PROJECT #: Project #3317-01  
RE: Comprehensive Permit  
Technical Review Response  
444 East Central Street  
Franklin, MA

On behalf of our client, TAG Central LLC, and in coordination with Beals Associates, Allen & Major Associates, Inc. (A&M) is providing the following responses to outstanding items noted in the letter dated November 10, 2025, from Hancock & Associates regarding the Comprehensive Permit. A&M's responses to final comments are shown below in **bold**.

PROJECT:  
**40B MULTIFAMILY**  
444 EAST CENTRAL STREET  
FRANKLIN, MA

DRAWING TITLE: <b>PROPOSED WETLAND BUFFER DISTURBANCE 25-50' BUFFER</b>	SHEET No. <b>EXH-7</b>
--	---------------------------

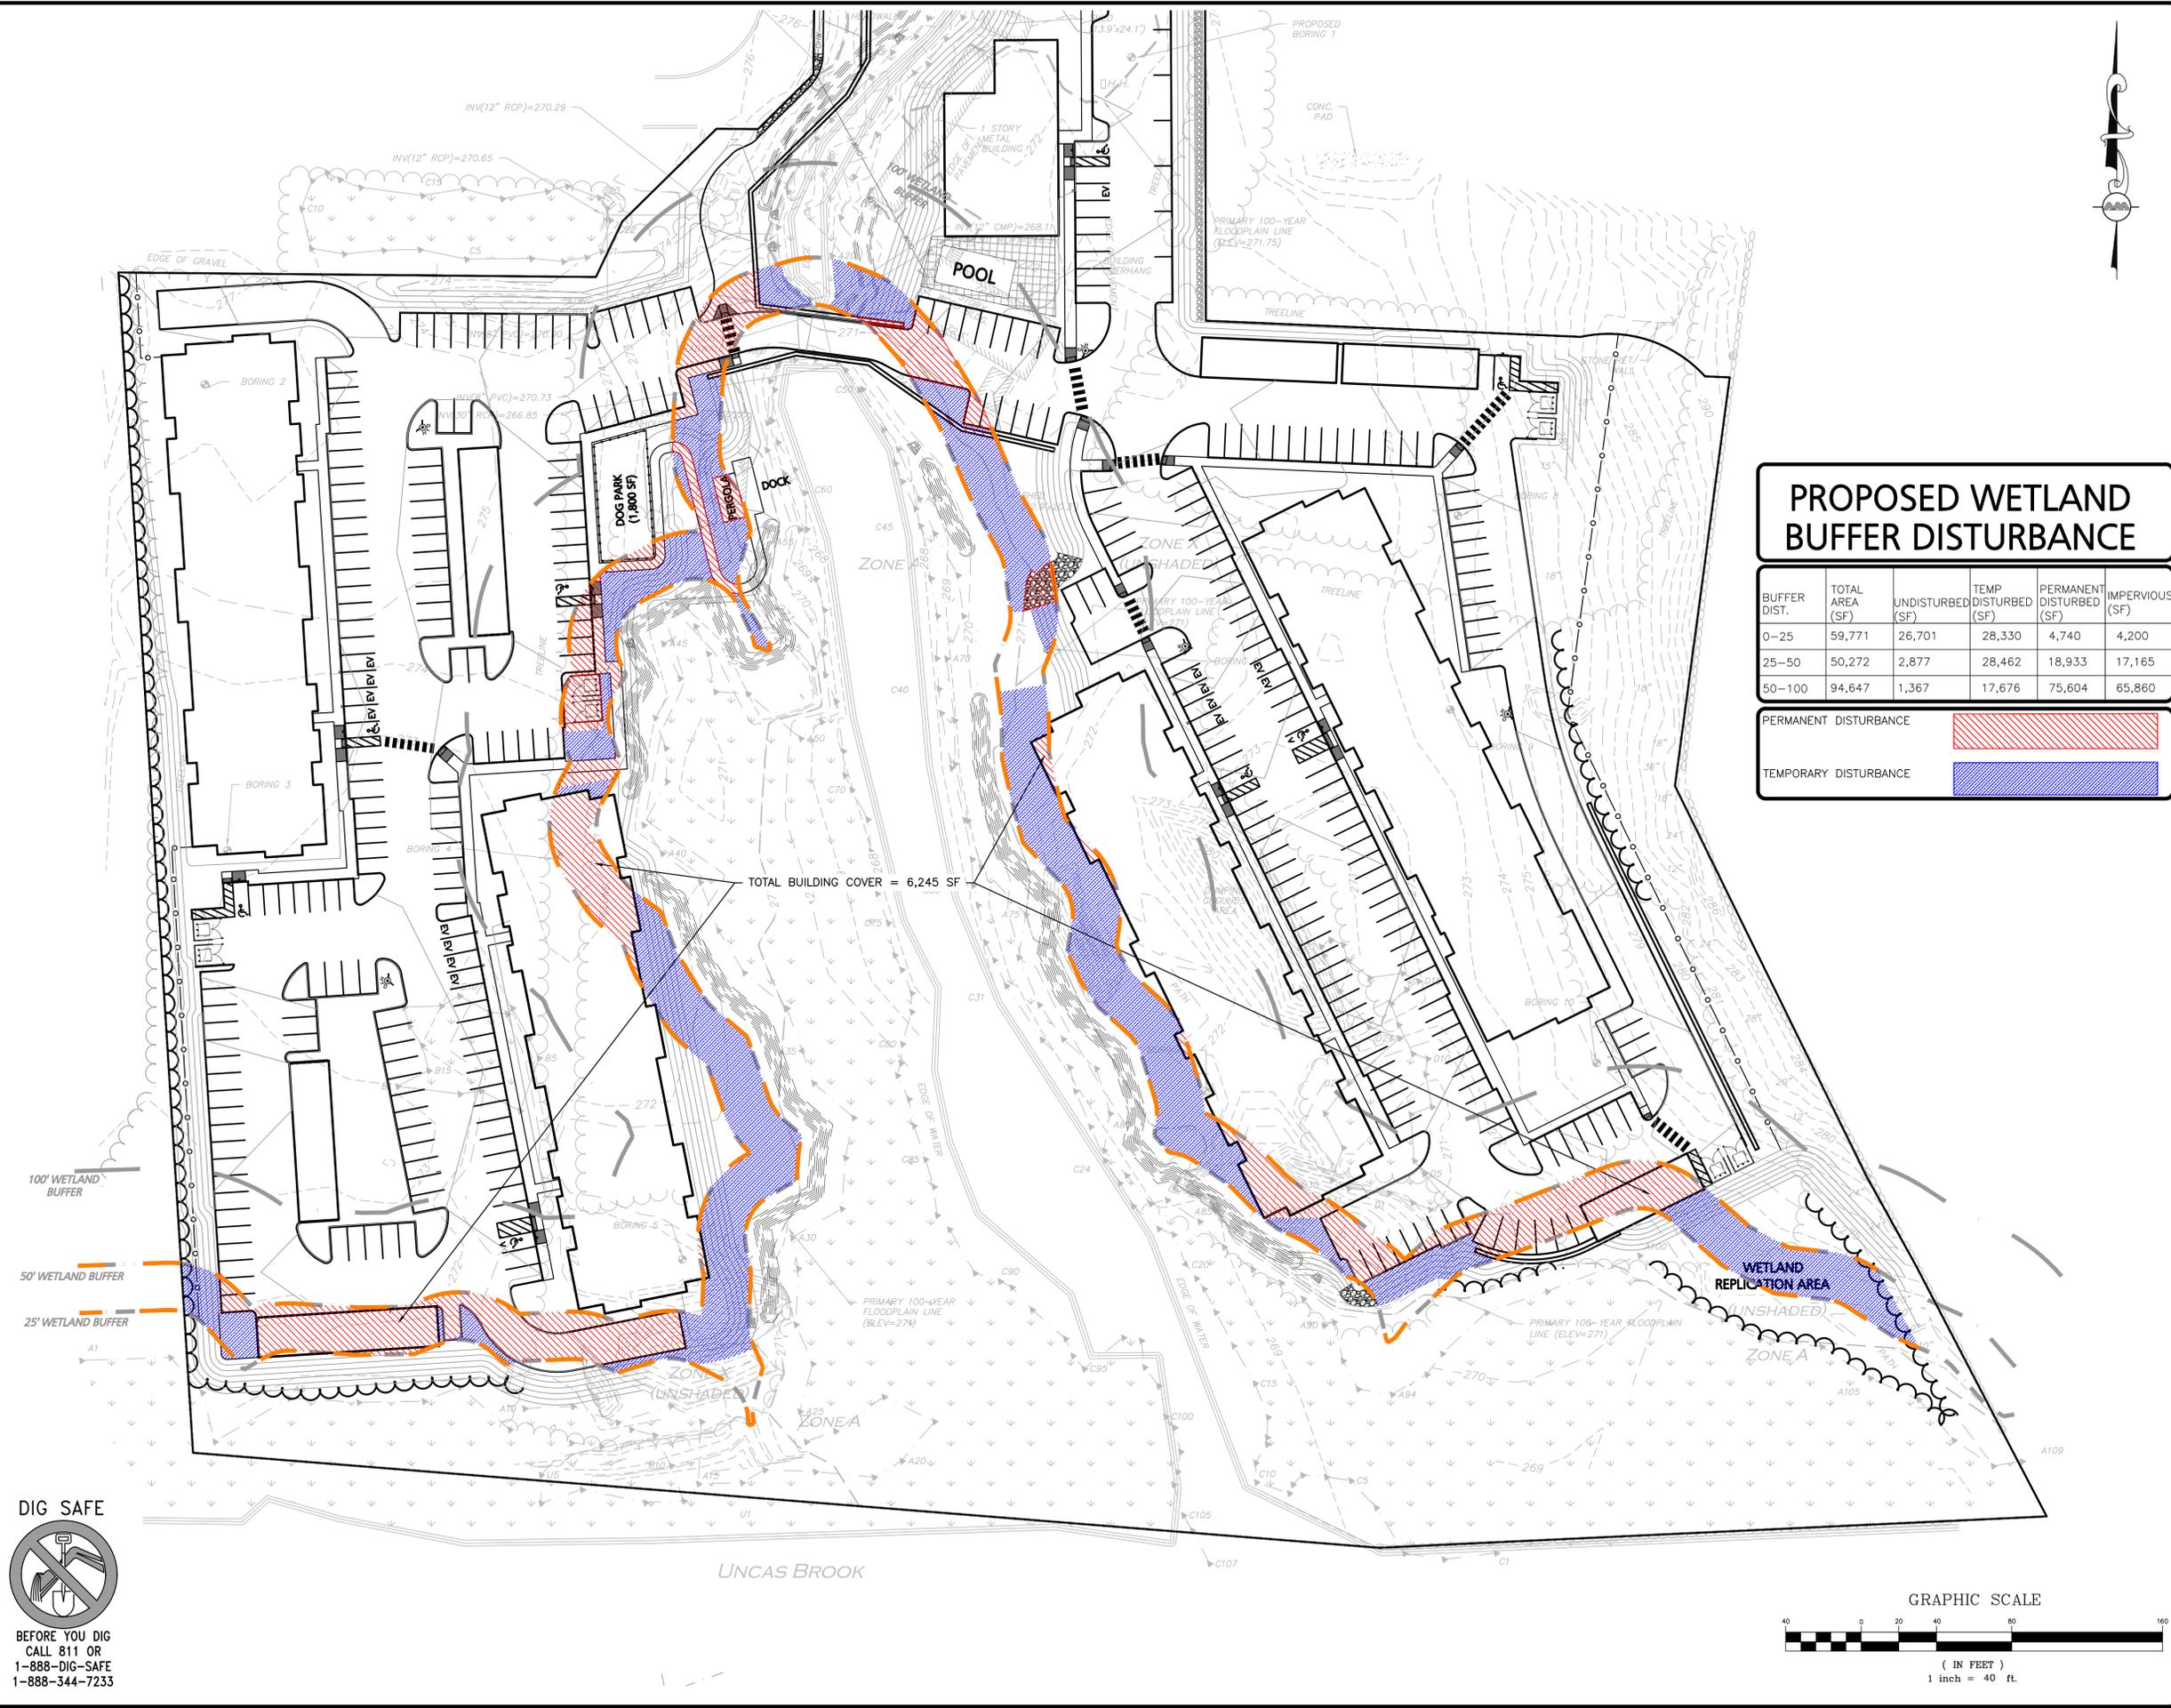
*The Applicant has submitted a revised List of Waivers dated October 29, 2025. At the last hearing on October 23, 2025, the Board requested clarification and to quantify the relief regarding the Wetland Franklin Wetlands Protection Regulations for the work within 25' of the wetland, structures within 50' of the wetland, the quantity of impervious within the buffer zone. Hancock suggests the Board require submission of alternatives analysis per Section 7.13 of the Wetlands Regulations to allow for proper deliberation of the other requested waivers.*

**A&M Response: As requested, please find attached a copy of the alternatives analysis per Section 7.13 of the Wetland Regulations to allow for proper deliberation of the other requested waivers; this was already submitted to and reviewed by the Conservation Commission and their peer-review consultant as a part of our Notice of Intent Application revised through 11/4/25. For brevity purposes, we extracted the alternatives analysis section only from the Notice of Intent Application and attached it to this letter. As for the Board's comment from the last hearing on 10/23/25, we've prepared an analysis entitled Proposed Wetland Buffer Disturbance analysis, which is attached hereto, that quantifies the work to take place within the 25' wetland buffers, 50' buffers, and quantity of impervious within the buffer zone. Given that the requested information has now been submitted, the Applicant considers this item closed.**
